STAFF RECOMMENDATION
505 North 16th Street
August 20, 2014

Application: New construction- outbuilding
District: Lockeland Springs-East End Neighborhood Conservation Zoning Overlay
Council District: 06
Map and Parcel Number: 08306031900
Applicant: Oswaldo Carpio
Project Lead: Allison Asbrock

Description of Project: The applicant proposes to construct a new two-car garage with a half-level above.

PROPOSED SITE PLAN

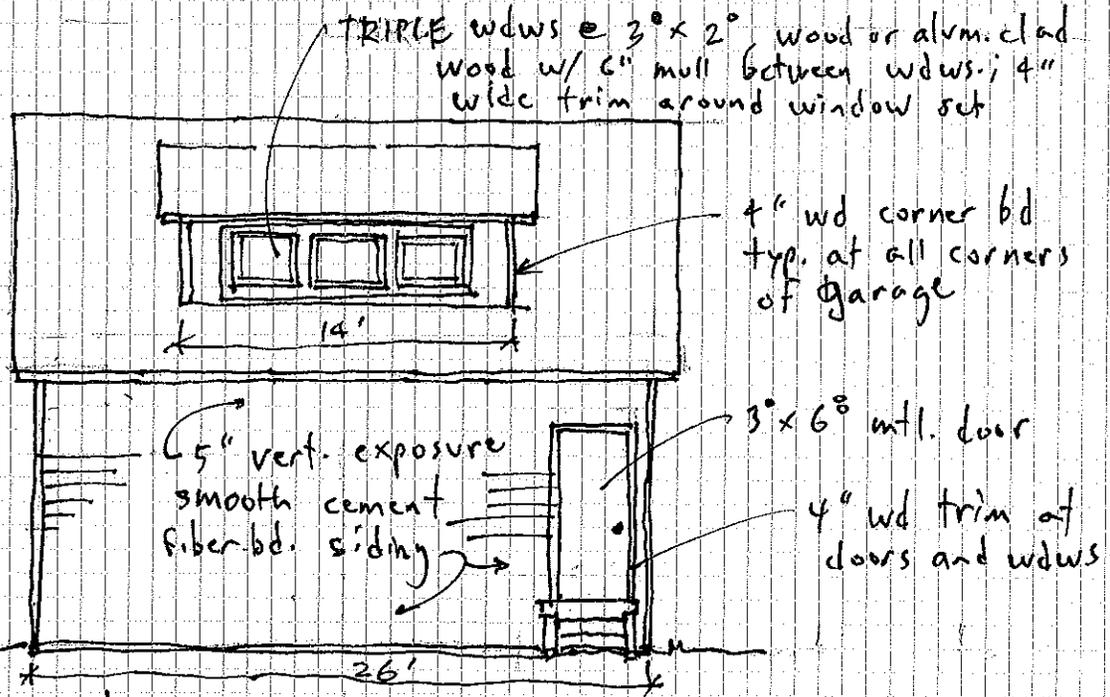
The new building will be located behind the primary building with the double garage door facing the alley to the side of the property and a single garage door on the opposite facade. The outbuilding will be thirteen feet (13') from the north side-alley and three feet (3') from the rear. This location is compatible with the location of historic outbuildings, being to the rear of the lot, and meets the bulk zoning requirements. Staff finds the project meets section II.B.8.b.

WEST ELEVATION

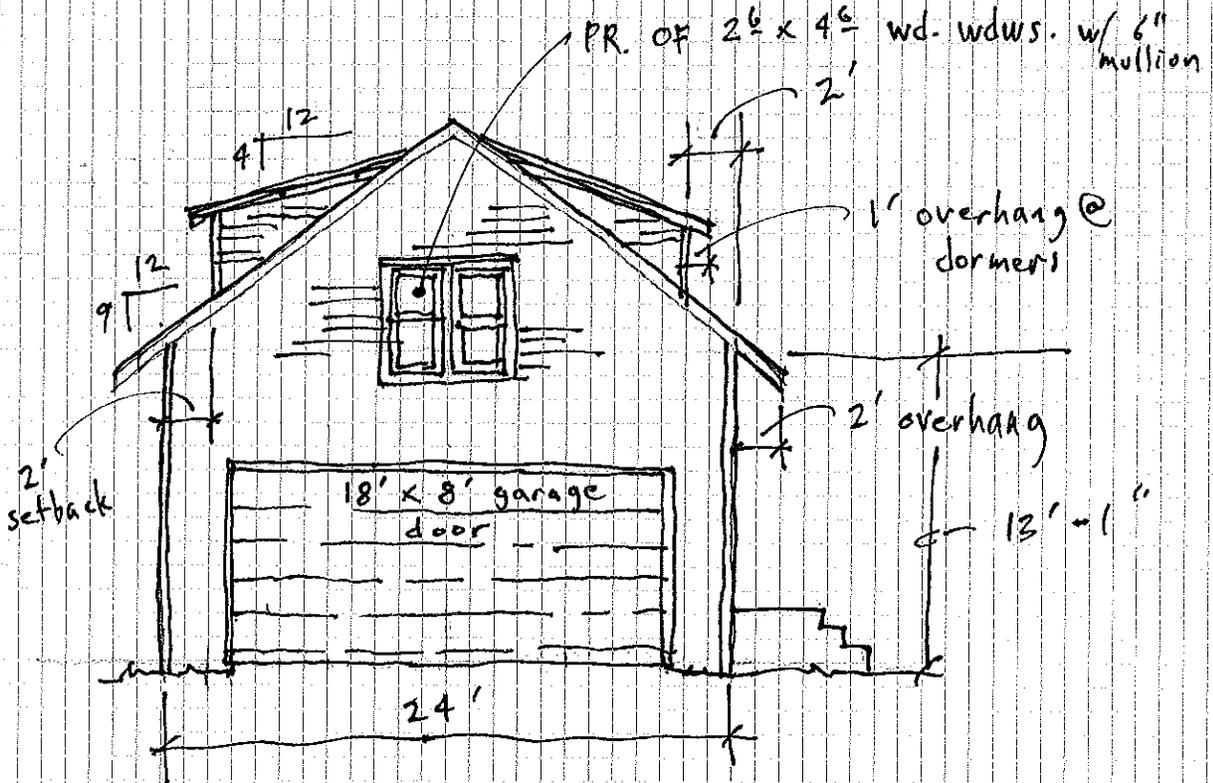
The proposed garage will be twenty-three feet (23') tall, approximately four feet nine and five eighths inches (4' 9 5/8") shorter than the height of the house after the half-story has been added. The first-story wall height is thirteen feet (13'), with an eave height of approximately eleven feet (11') above grade, which is one foot taller than the existing house, again after the half-story has been added. Staff finds the proposed eave and ridge heights to be appropriate for an outbuilding.

The primary roof of the outbuilding is a side-gable with a pitch of 9:12. Two shed dormers with a roof pitch of 4:12 will be located on with one on each the east and west elevations. The two dormers sit off the wall by the necessary two feet (2') and are appropriate. These roof forms are compatible with the main house and the surrounding context and staff finds them to meet sections II.B.8.a.

FIRST FLOOR PLAN

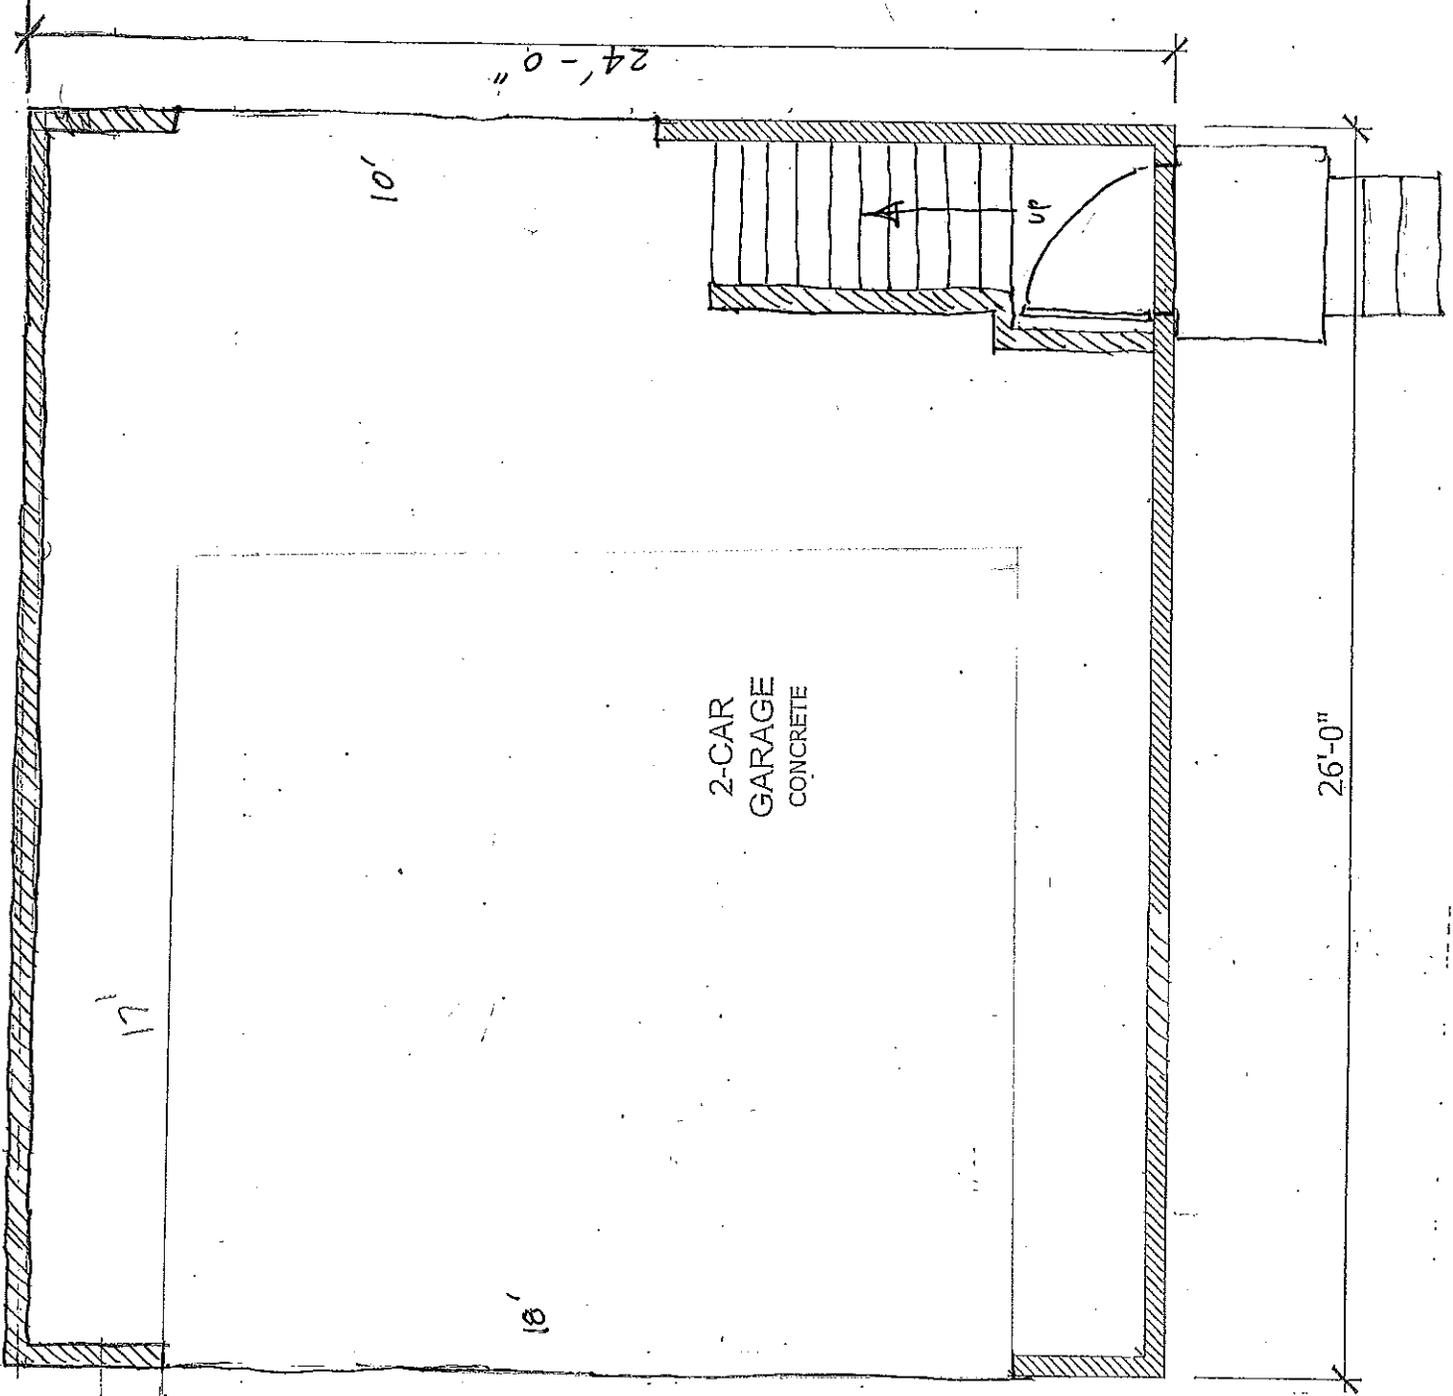
reduce ~~to~~ ALLEY
 24x27
 lower = 528
 upper = 328
 8106

A restrictive covenant may be required by codes for a full bath. Living space is not approved as part of this permit.
